MEETING AGENDA
CITY PLAN COMMISSION
Wednesday, May 8, 2024
Work Session 9:00 a.m.
Public Hearing: 10:00 a.m.

- 1. **PP-19-008 Tradition Central and Southern Phases: (Revision/Waiver Request): 2,307 Single-Family Detached Residential Lots and 79 Private Open Space Lots. ETJ-Denton County.**
 - a. Being approximately 780.76 acres situated in the Guadalupe Cardinas Survey, Abstract No. 214, located in the City of Fort Worth, Tarrant County, Texas.

2. **PP-21-045 Normandy Farms: (Revision): 127 Single-Family Detached Residential Lots and 10 Private Open Space Lots. Council District 10.**

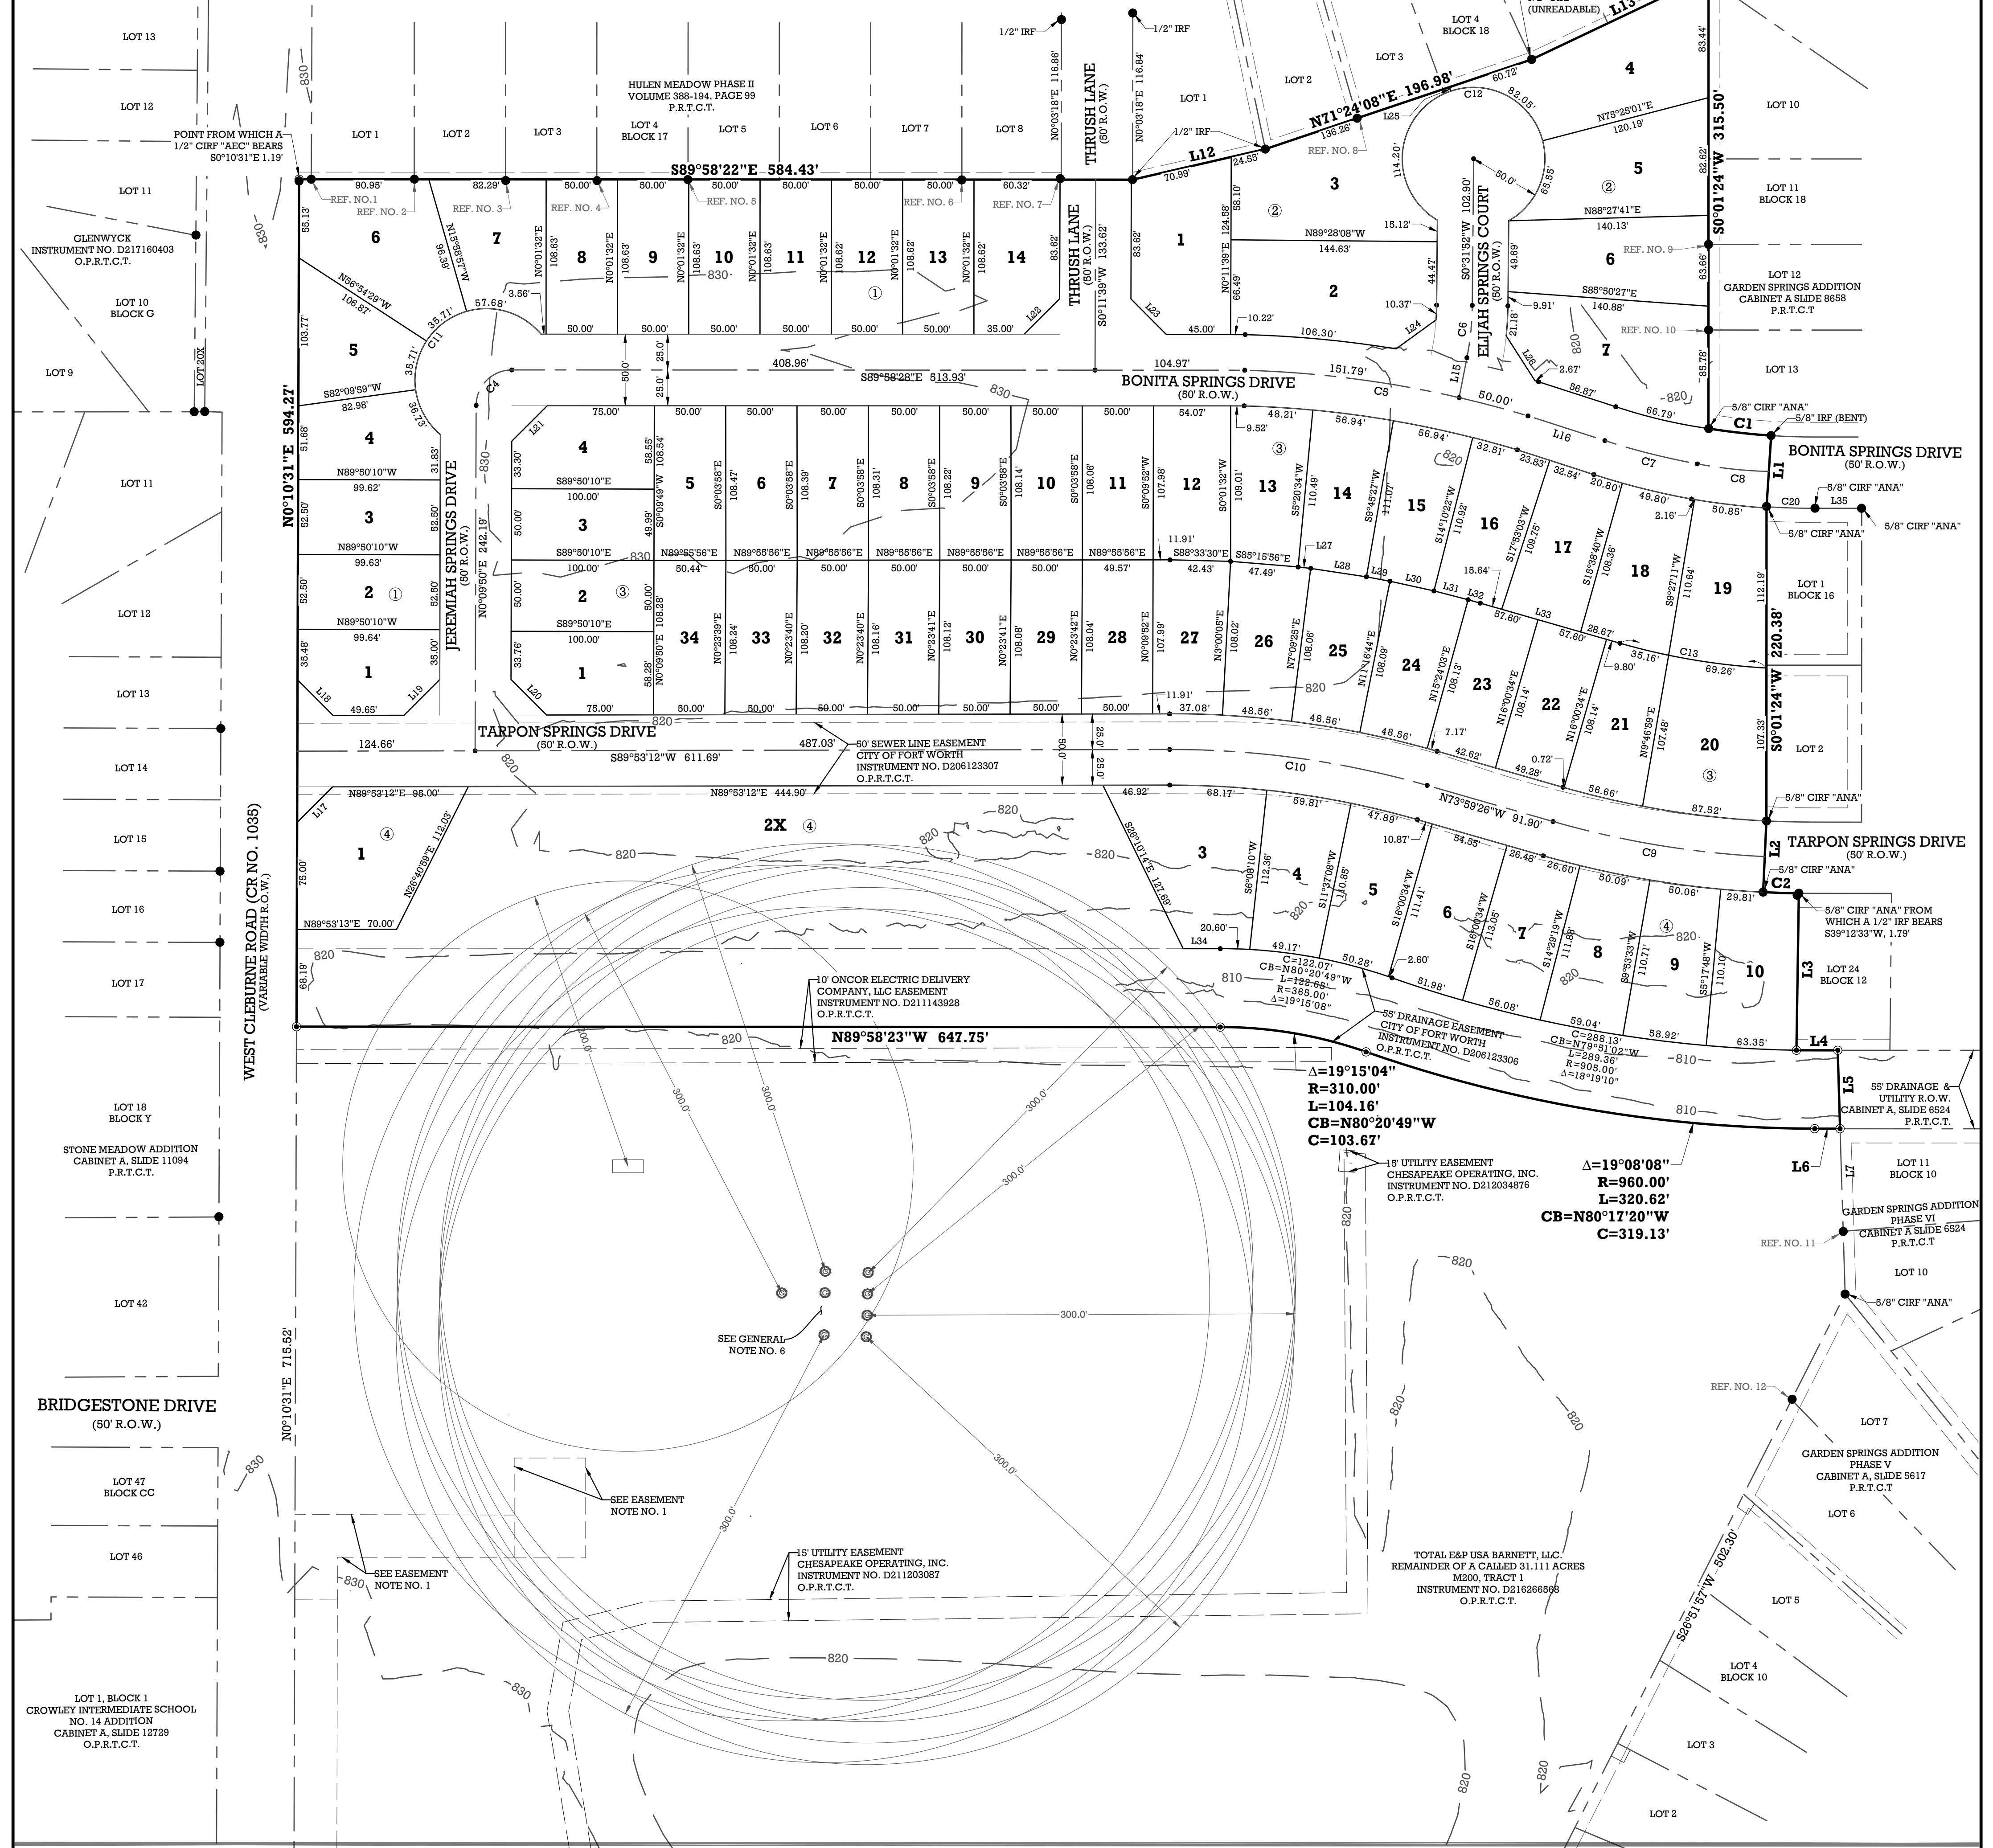
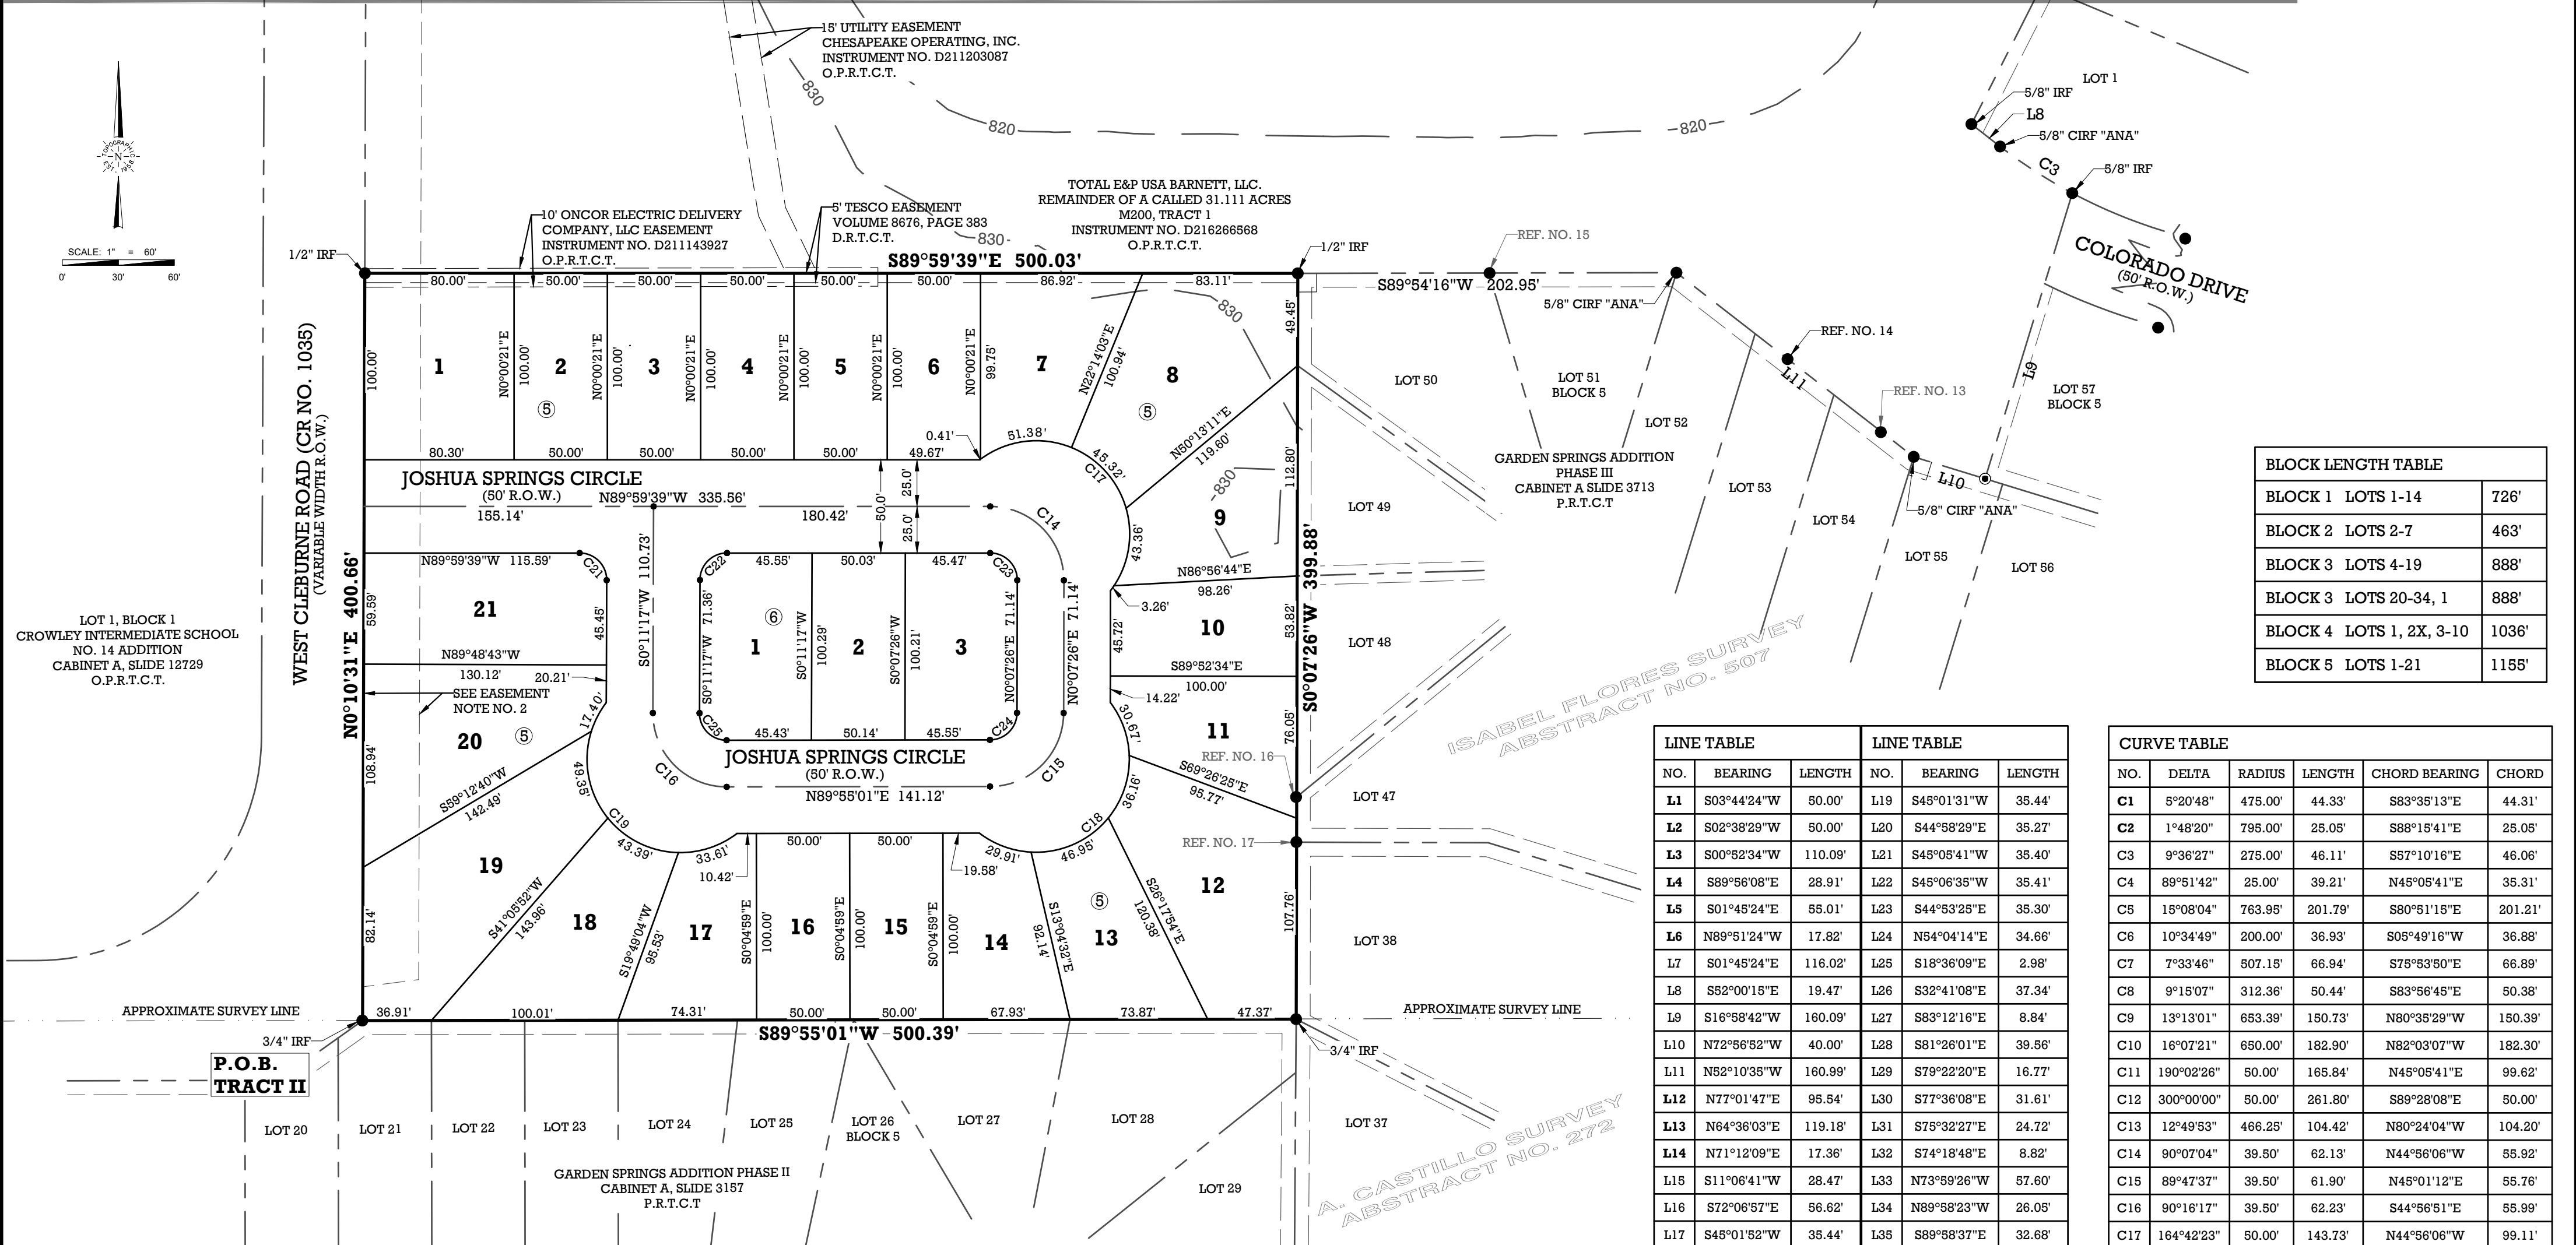
The applicant in proposing a revision to the previously approved preliminary plat from 105 lots to 127 lots, which is an increase of 8.0% and requires City Plan Commission approval.

The Subdivision Ordinance in Section 31-63 (b) (5) gives DRC the authority to approve minor revisions to the preliminary plat including a net increase, not to exceed 5% of the total residential lots (rounded to the nearest whole number) in the overall lot yield of the approved preliminary plat. Since this exceeds, that threshold City Plan Commission action is required for the approval.

The DRC recommends approval of the requested Preliminary Plat revision because the change is consistent with zoning and the infrastructure is adequate to support the increase in the number of residential lots. This revision does not create the need for a Subdivision Ordinance waiver.
